# Appendix A Bowes Controlled Parking Zone Revised Proposals - January 2019

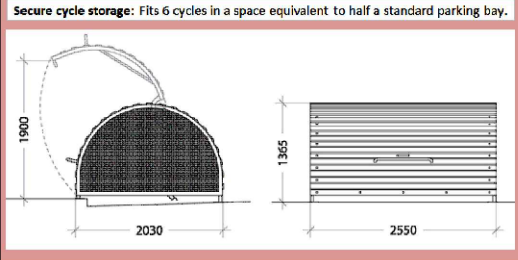
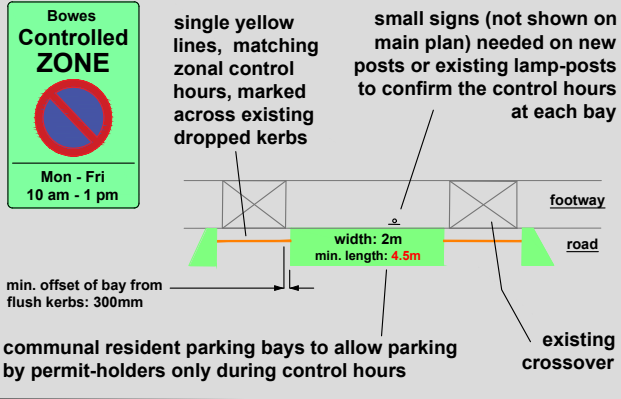
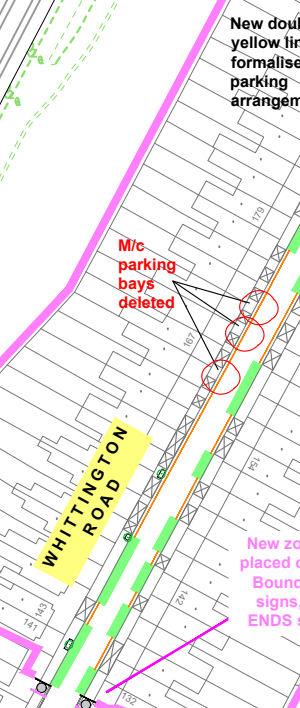
Footway parking lines added to square off terminus. New 4.5m bays (was 4.0m) and double yellow lines will formalise existing parking arrangements whilst maximising local capacity. Marking bays at spots where parking would be obstructive is not suitable.

**Reconfigured Turning Head:**  
Three 4.5m long bays replace double yellow lines at terminus. Extended section of double yellow line on eastern kerbline retains manoeuvring space for bin lorries for the loss of one parking space.

Some residents said proposed cycle parking would remove too much space needed for cars.  
**Response:** Five of the ten hangars are relocated to helpfully located build-outs. Under the revised proposals the 3.5km of communal-use kerbside space across the zone is allocated as follows:  
**Resident Bays: 97% | Disabled Bays: 2% | Cycle, Motorcycle & Car Club Spaces: 1%**

5.75m long bay for up to 4 motorcycles with locking posts now proposed, plus additional cycle hangar, both being in response to local demand expressed at consultation stage. 3 households in this street commented on need for m/c storage, while existing cycle hangar to south has a full compliment of 6 users as of Jan 2019 with 9 people (some within this street) on the waiting list, indicating a demand for extra spaces nearby.

Placement of proposed bays assumes crossover is redundant

Proposed bike hangar to be installed within junction build out, improving access to secure cycle storage for residents without garages/gardens

Proposed bike hangar to be installed within junction build out, improving access to secure cycle storage for residents without garages/gardens

Cycle hangar deleted; this site does not afford the full 450mm clearance from the crossover, under the revised threshold

**Overall Spencer Avenue residents wished to remain outside the zone, to avoid single yellow lines being marked across driveways.**

**Response:** Government advice prescribes this treatment within CPZs, and it has been applied across all Enfield's other zones. The single yellow line prohibits parking by any driver during the control period but does not stop residents parking across their own dropped kerbs at any other time. It provides clarity to the visiting driver on where parking may occur within the zone and guards against nuisance parking being displaced from bays onto crossover locations during the control period. The ability of a householder to park across their own dropped kerbs, to the exclusion of other drivers, is a side-effect of having a crossover. The householder enjoys no explicit right to park at the dropped kerbs. The unpopular clustering of motorcycle bays at Spencer Avenue has been deleted and the street left within the revised proposals to re-test local support. Should levels of support elsewhere remain high, residents and the Council must consider whether it is wise to leave Spencer Avenue outside the zone. This might risk focusing unwanted parking from the other nine streets, and the adjacent zones beyond, onto this street alone.
